HP Rocher 1.0 RFQ

PROJECT : ROCHER
Quanta Computer Inc.

Y0E Schematic EC Tracking Record A to C version(DB/PV Planar)

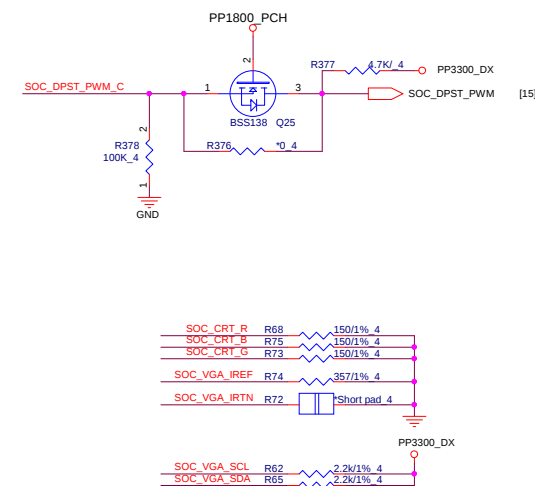
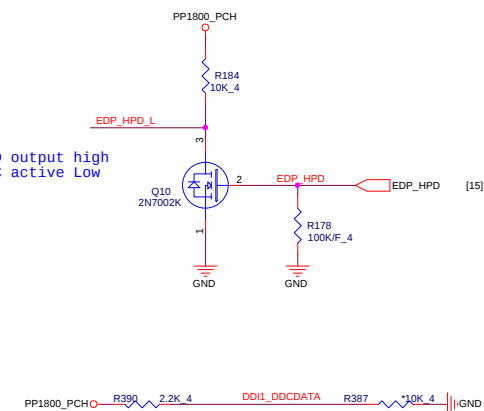
Need to discuss with BIOS

Check BIOS Socket

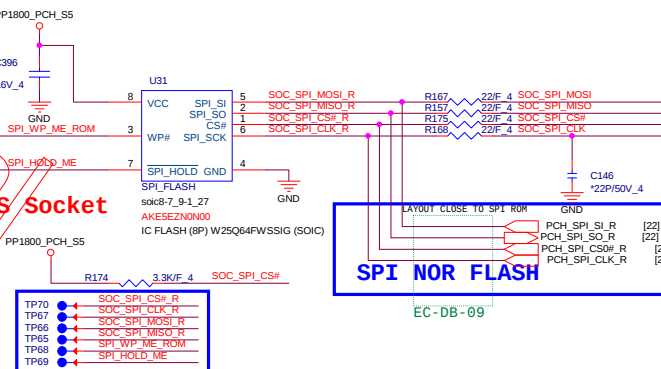
Need place to TOP side

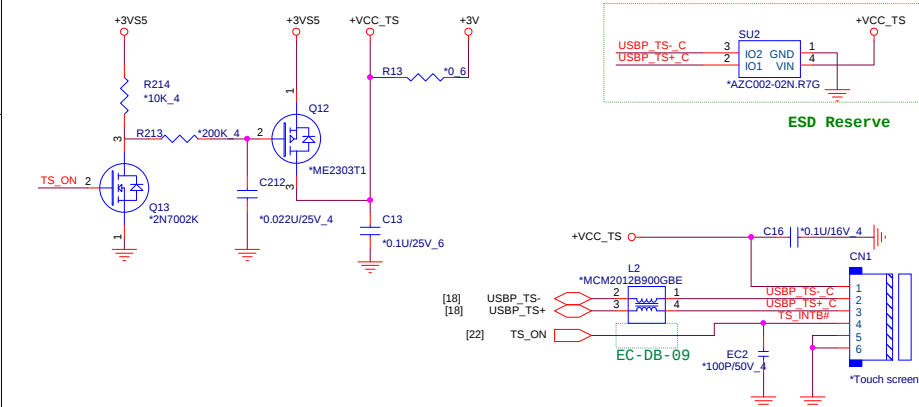
eDP/LVDS
Need New LCD Cable

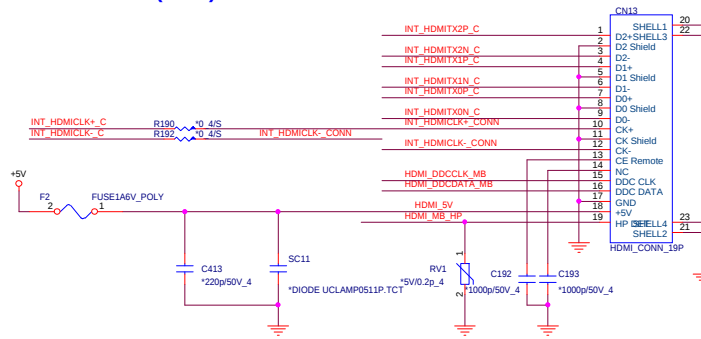
ESD 靠近HDMI CONNECTOR(CN9)

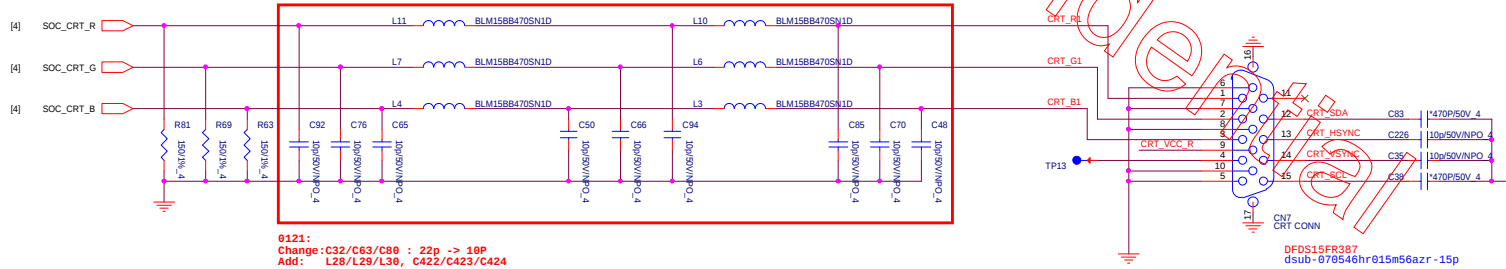
0121:
Change:C32/C63/C80 : 22p -> 10P
Add: L28/L29/L30, C422/C423/C424

Internal Speaker

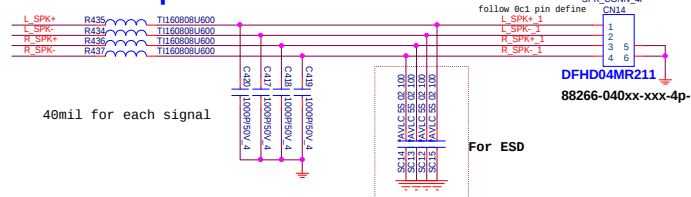
Check layout mount location

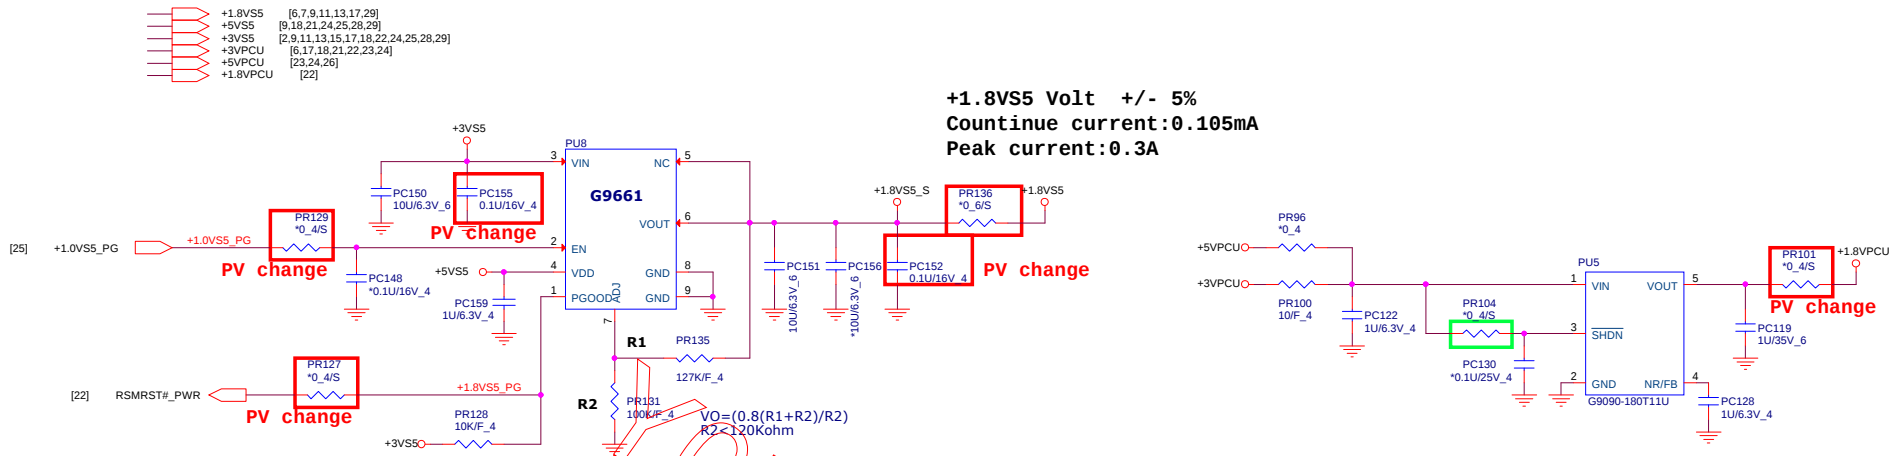
Delete PU7
